Access Compliance Report

Public Rights-of-Way

(Curb Ramps)

Intersection ID: 32303	Main Street: EMPIRE_WOODS_CT	Cross Street: TRAVIS_GULCH_DR	Location: SW
ADA ID: CCAB79B013DA	Ramp Type: PerpDiag	Initial Pass/Fail: Pass	Overall Compliance: No
		Severity Score: 10

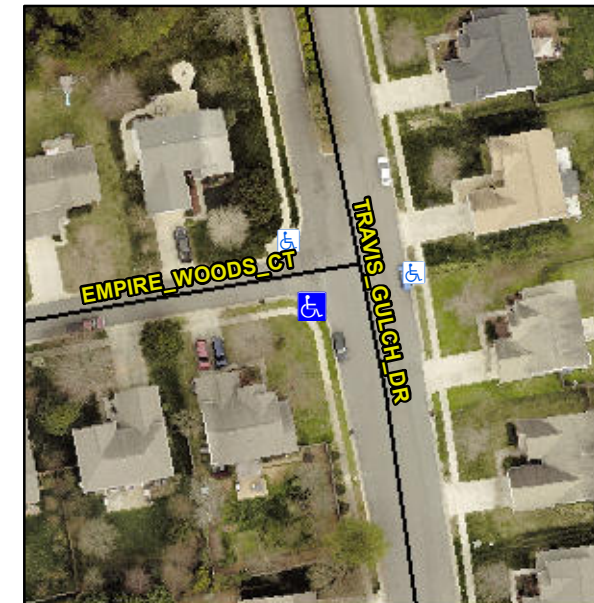
R304.2.1, R304.2.2-Perp, R304.3.2-Para, R304.5.3, R305

Remove & Replace Curb Ramp With Two New Directional Ramps or Equivalent.
